Contract No. 22221 PF0
Fullerton Fire Station #8 Renovations & Addition
(4401 Fitch Avenue, Nottingham, Maryland 21236)
Nottingham – District 14c5
Workday No. 200540012

ADDENDUM NO. 3

DATE: 12/20/2024

PROJECT:	Fullerton Fire Station #8 – Renovation & Addition	MWS PROJECT NO:	20-120
ADDRESS:	4401 Fitch Avenue Nottingham, Maryland, 21236	CONTRACT NO.	22221 PF0
		ISSUE DATE:	December 19, 2024

1 FIRST FLOOR FINISH PLAN
1/8" = 1'-0"

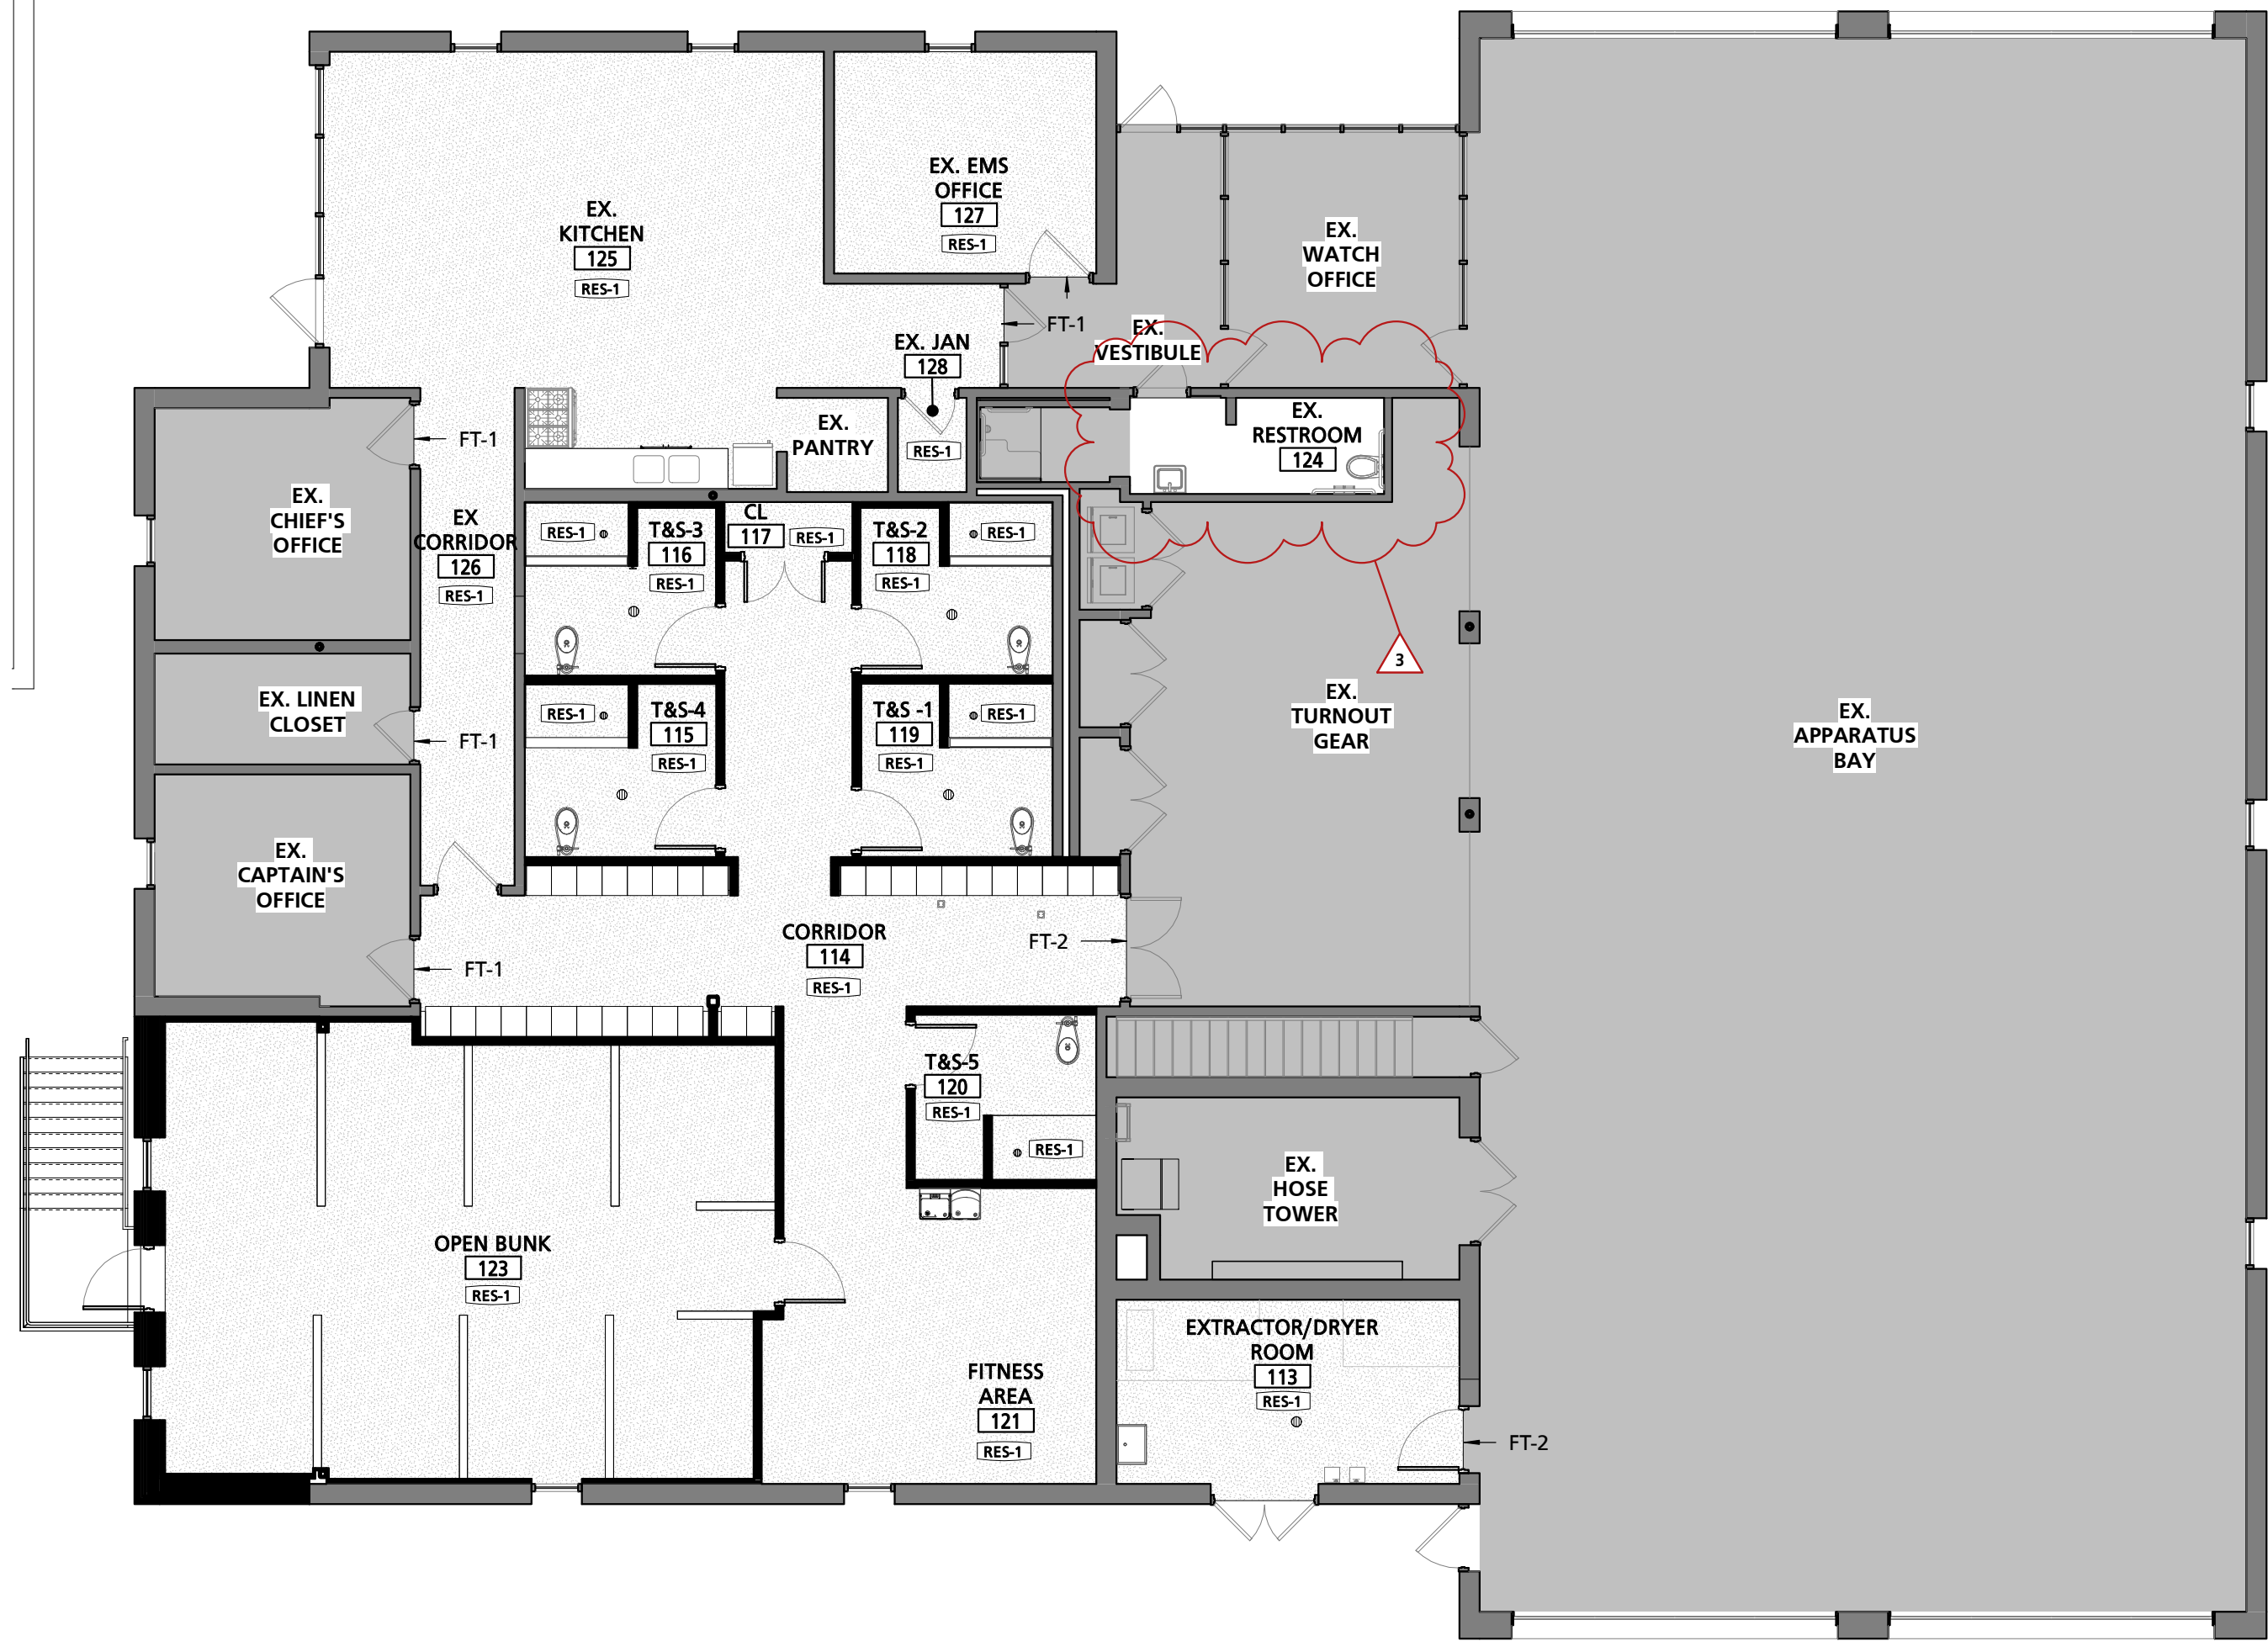
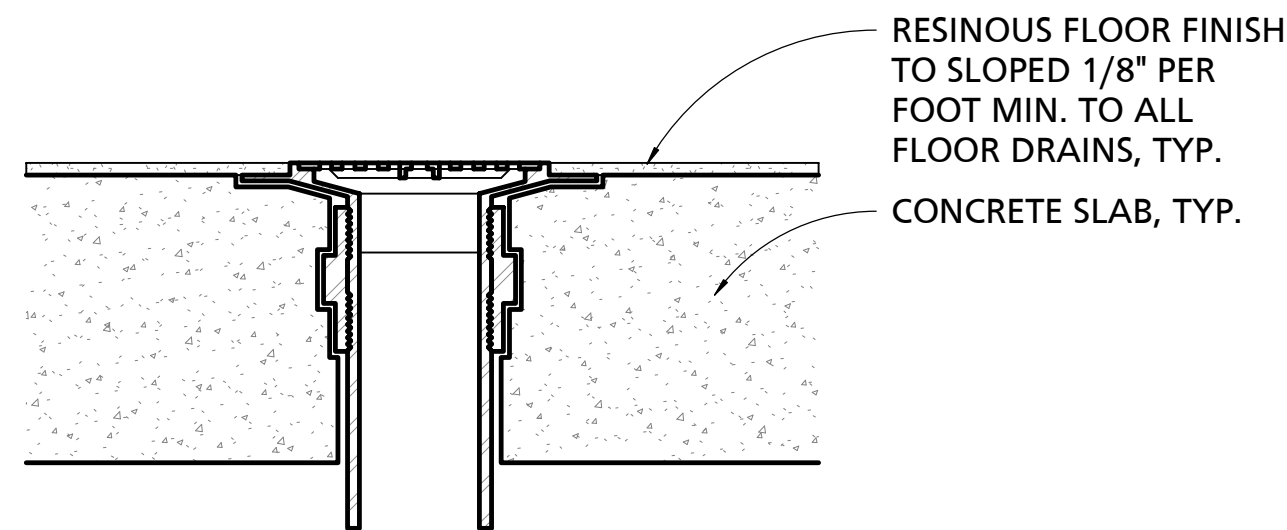
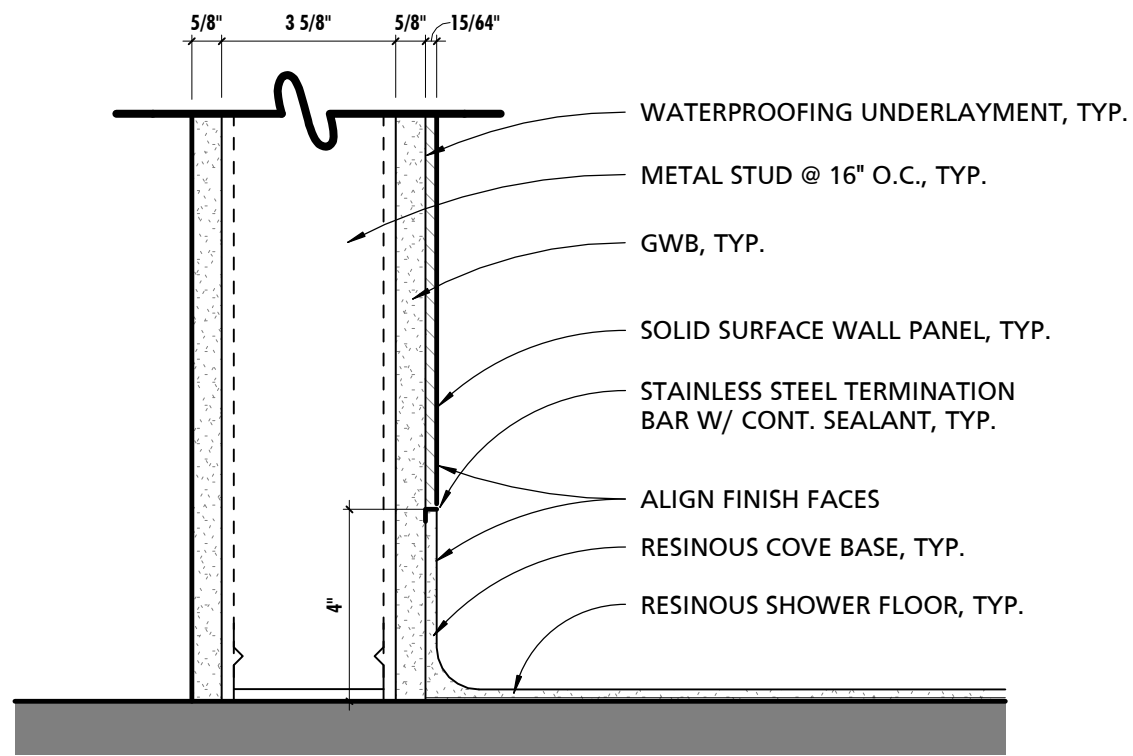
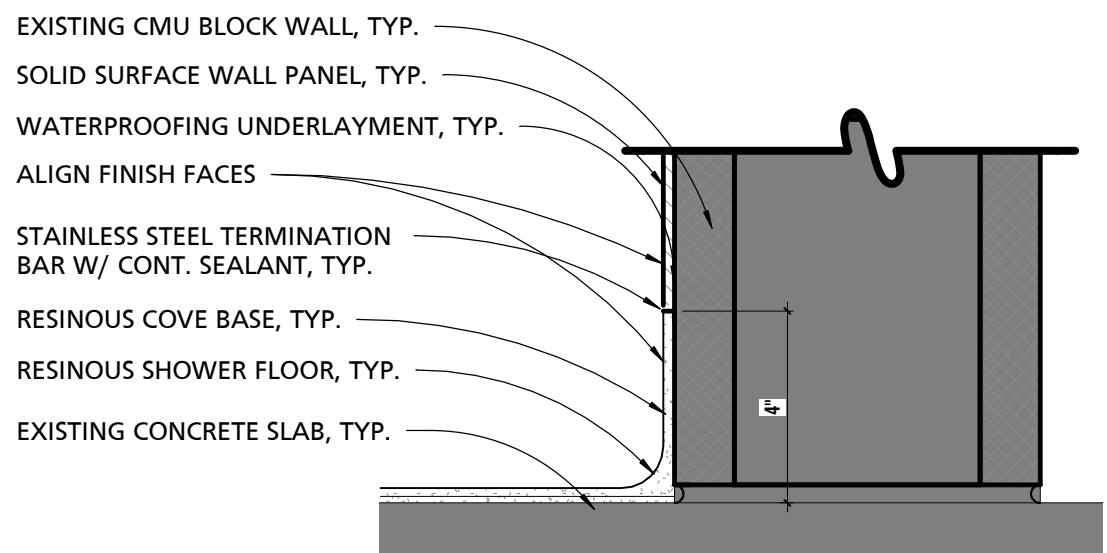
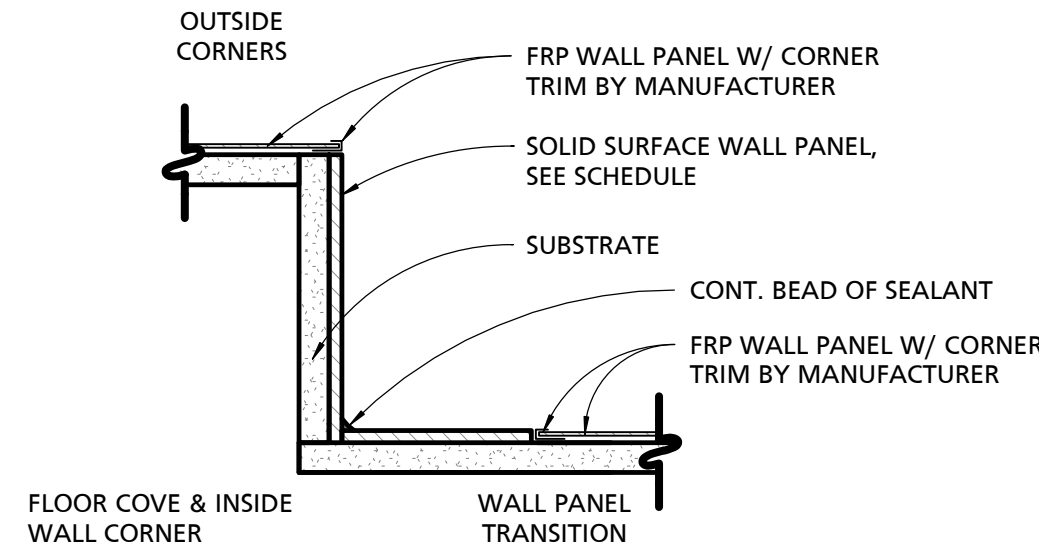
31.)QUESTION: About the finish schedule... It shows 124 getting the resinous flooring treatment, but that room is shaded dark grey meaning it is not in scope. Can you confirm whether this room is to be included?

RESPONSE: Room 124 shall receive resinous flooring per the finish schedule. See amended drawing A100, A102, and A103.

SHEET DESIGNATION	CONTRACT NUMBER
A500	22221 PFO
	JOB ORDER NUMBER
	241-220-0054-0012
	SHEET 23 of 58
	DRAWING NUMBER
	2022-2341
FILE NO.: s	REV

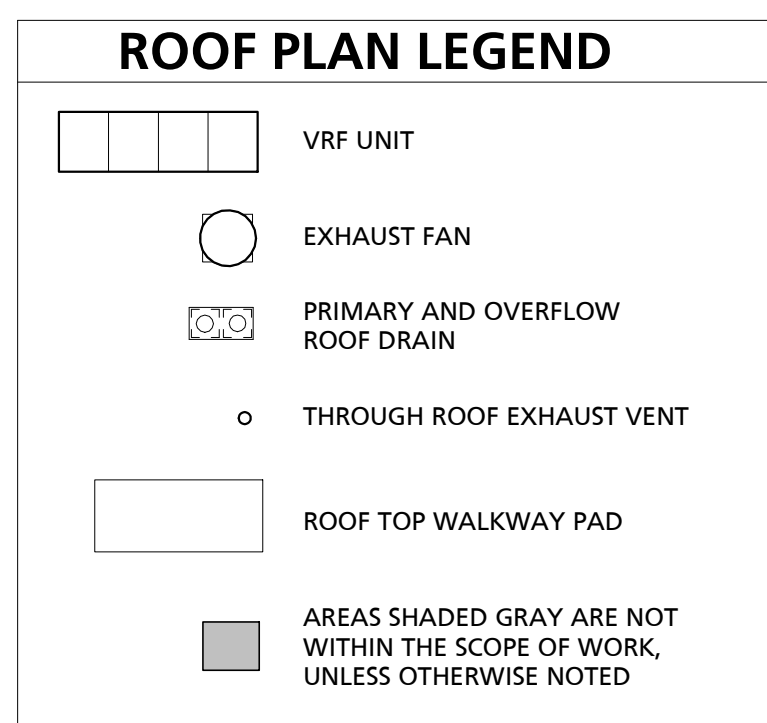
- 5.) **QUESTION:** Details 1&2/A500 show a shelf angle supporting the light gauge cornice. Please provide structural details.

RESPONSE: Refer to revised detail 2/A500

SD72

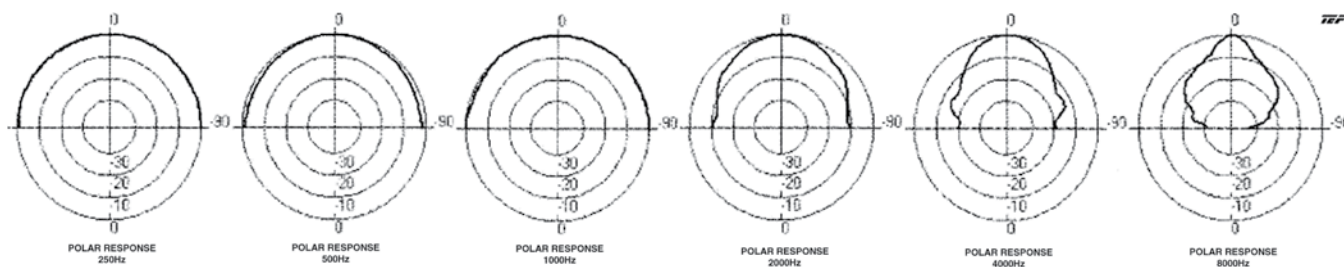
36.)QUESTION: Does the symbol SP stand for a speaker? The note says to re-use but there are also new speakers. What type speaker is needed?

RESPONSE: Yes, SP stands for speaker. Speaker - Attached is the spec sheet for the an 8" Atlas Sound Ceiling Speaker. Model SD72W comes equipped with the speaker grill. Wire - 2 Conduct 16AWG Wire From Digikey to connect the speakers: Part number E1042S-41
